Resource consent application – Further information request

Application number(s):	BUN60393755, DIS60393756, LUC60393757, WAT60393758, LUS60393759
Applicant:	The Bears Home Project Management Ltd
Address:	670 Muriwai Road, Muriwai Valley
Proposed activity(s):	The construction, operation and maintenance of a golf course, sports academy and luxury accommodation complex, including all associated ancillary buildings, structures and activities (the project).

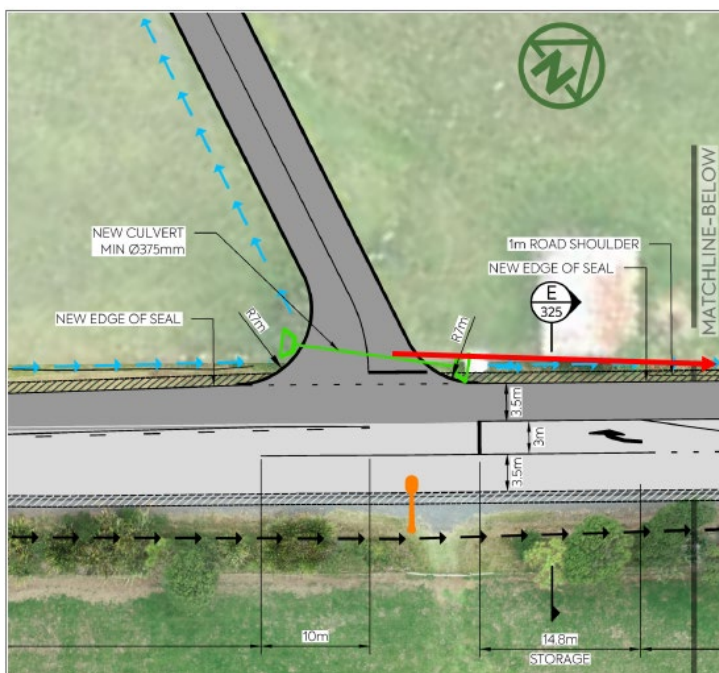
12. H19 Rural Zone policy is to avoid, remedy or mitigate adverse effects on traffic movement and the road network. Given the proposed site anticipates 92 vehicles/hour in the peak hour and no alternatives to motor vehicle access to the site are available at the proposed location, please provide sufficient evidence that the rural nature of Muriwai Road and the rural character of the area will not be adversely impacted. Please provide a travel plan or other evidence that car trips to the site will be reduced as far as practical.

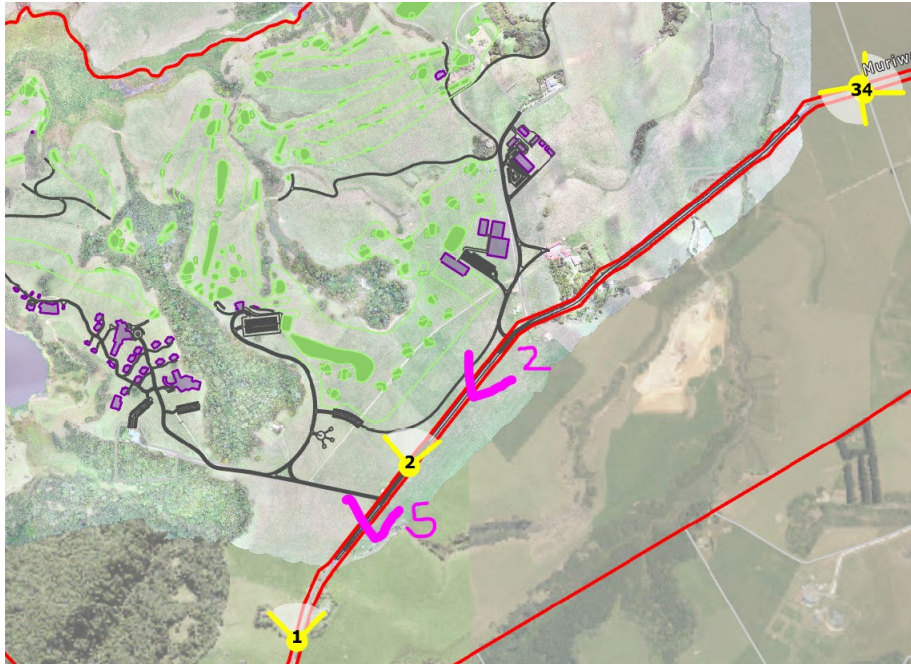
31. Please clarify the thicknesses used for each layer in the assessment of settlement effects. Please clarify what the expected effect of 100 mm of settlement at the road is?

Context: For the assessment of ground settlement, we note that a maximum settlement 170 mm has been calculated with up to 100 mm of settlement calculated at the road. This seems quite large considering the nature of the ground. Clarification on the thickness of compressible material assumed is required.

32. Given the relatively wide drawdown contours what differential movement is expected and what is the risk of damage to the road?

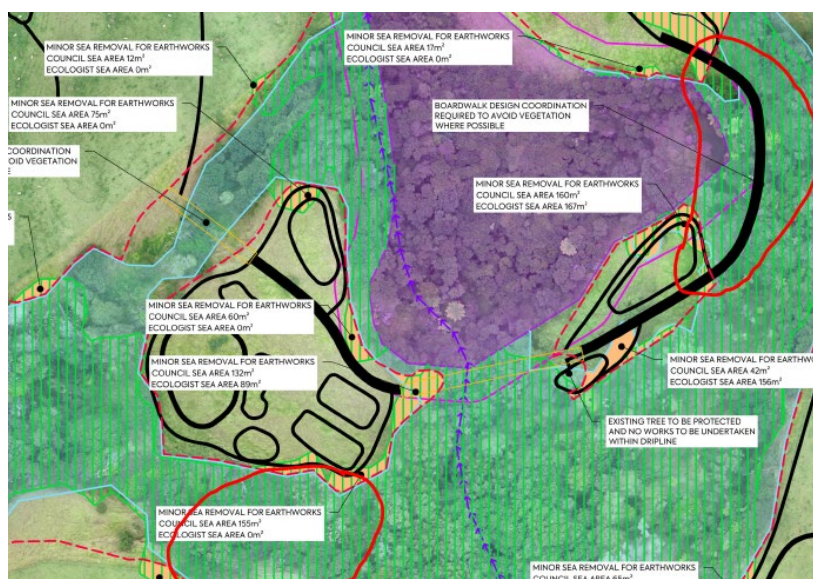
56. The area of vegetation clearance has been calculated from the mapped vegetation edge undertaken by RMA Ecology. While I understand this approach, and it is required given the cumulative vegetation removal thresholds in E15.4.1 (A10), the total amount of infringement into the SEA overlay is still required to be understood.

It is noted that the RMA Ecology Report states approximately 1,396m² of vegetation clearance and this estimate is said to be conservative. However it is my understanding that this only accounts for area of vegetation loss, rather than extent of SEA loss. I cannot see any cumulative totals for the loss of SEA extent or non-SEA native vegetation for the entire site. Estimates of actual loss of SEA extent appear to be more in the region of 7,674m² according to the McKenzie and Co. "Clearing plans". Areas of SEA will be permanently removed (comprising of both native vegetation and rank grass) and turned into golf turf which provides no ecological value and represents a net loss of SEA. Please provide calculations on the total extent (m²) of SEA area loss for both SEA areas (as per AUP-OP overlay) and non-SEA indigenous vegetation (as per RMA ecology). Please provide an assessment into how the effects of this permanent removal of SEA will be offset.

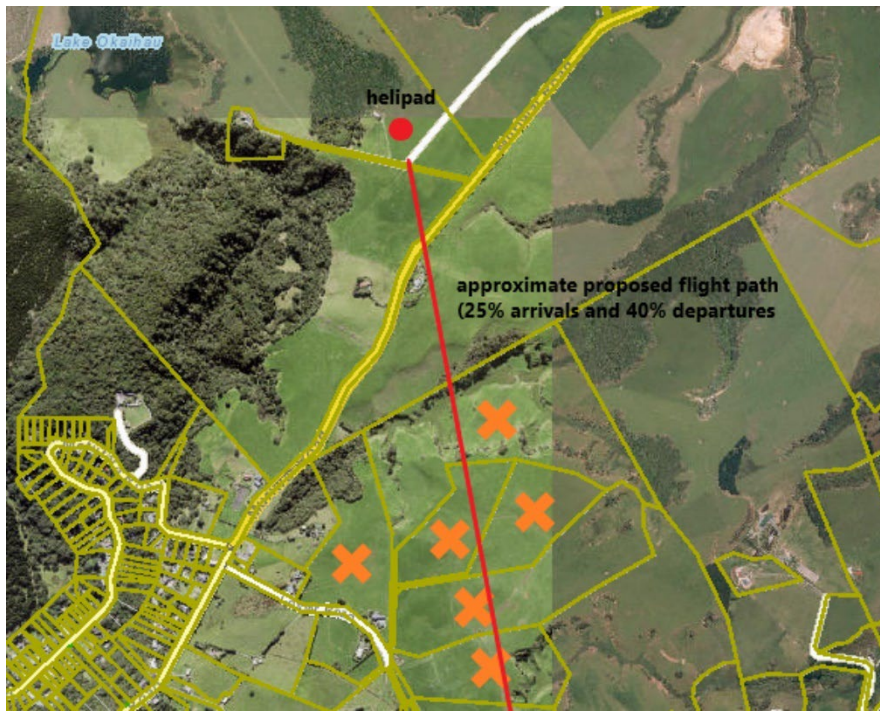
109. The AEE has outlined general information regarding the proposed outdoor lighting at the site that will be utilised for general pedestrian and operational safety, architectural features and landscape planting. However, a full assessment of the lighting with respect to Chapter E24 has not been undertaken. While exterior lighting can be readily designed to comply with the Permitted Activity standards in the chapter, I consider that due to the nature and large scale of the proposed project, a lighting assessment should be undertaken as part of this application. On this basis, I request the applicant provide a lighting report prepared by a suitably qualified lighting specialist to assess the proposed exterior lighting against the provisions of chapter E24 of the AUP(OP). This lighting report should outline the proposed lighting and confirm compliance with each of the standards contained in chapter E24.

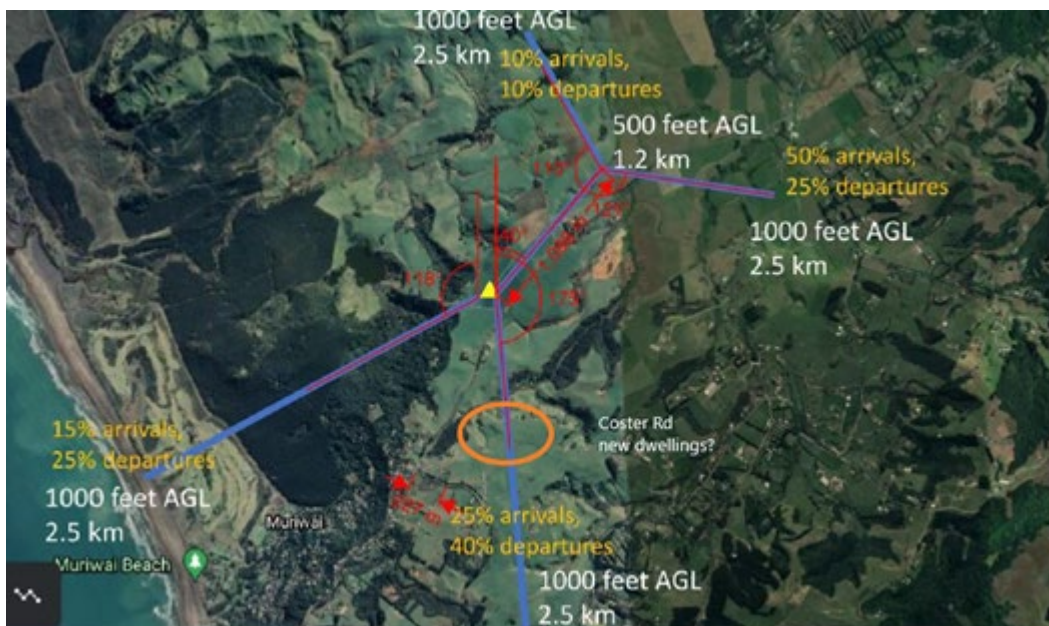
As shown in Figure 7, the predicted 50 Ldn noise contour is located entirely within the application site. However, I note helicopters using the proposed southern flightpath (25% arrivals and 40% departures) may overfly future dwellings in Coster Road. (Individual lots shown with orange "X")

110. Please advise what the “typical” ambient and background noise levels are at the application site in regard to average daytime and average night-time LAeq and LA90 levels based on any measurements carried out in similar rural environments.
111. Please confirm the relevant permitted construction noise standard as reference is made to 70 dB LAeq in section 3.1 and 75 dB LAeq in section 3.4. (Note: as the total project duration will exceed 20 weeks and construction noise arising across the site is likely to be audible to the nearest receivers, the long-term duration standard of 70 dB LAeq is considered to apply).
112. As shown in Figure 6 reproduced below, the proposed southern flight path is above potential future dwellings in Coster Road. If future dwellings are constructed on these lots, please comment on effects from helicopter flyovers.
